# MPC5121e (M36P) Errata

This document identifies implementation differences between the MPC5121e, M36P (Rev. 1), and the processor's description contained in the *MPC5121e Microcontroller Reference Manual* and the *MPC5121e Microcontroller Data Sheet*. Refer to <http://www.freescale.com> for the latest updates.

**Figure 1.  $V_{BAT\_RTC}$  to  $V_{DD\_CORE}$  Timing**

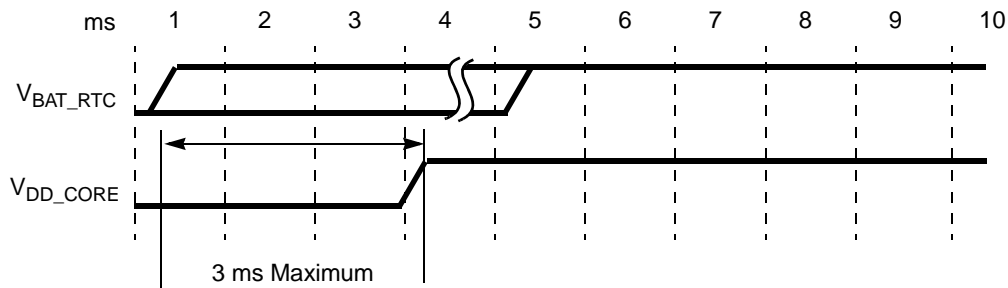
The Real-Time Clock (RTC) oscillator may not start properly when the  $V_{BAT\_RTC}$  power domain is active and  $V_{DD\_CORE}$  is transitioning from power-off to power-on.

When the  $V_{BAT\_RTC}$  power domain is active and the  $V_{DD\_CORE}$  transitions from off to on, the RTC time base becomes unreliable. The functionality of the oscillator and clock feeding the RTC counter is in one of three states:

Ensure that the  $V_{BAT\_RTC}$  power domain does not lead the  $V_{DD\_CORE}$  by more than 3 ms, or toggle  $V_{BAT\_RTC}$  after  $V_{DD\_CORE}$  has been turned on. The 3 ms is measured from  $V_{BAT\_RTC}$  at 50% to  $V_{DD\_CORE}$  at 90% of full values.

$V_{BAT\_RTC}$  can be powered concurrently with or enabled by  $V_{DD\_CORE}$ . Cycling  $V_{BAT\_RTC}$  power will result in the RTC counter being reset. See item 4 below. Following this workaround measure eliminates the need for measures 2 and 3 below.
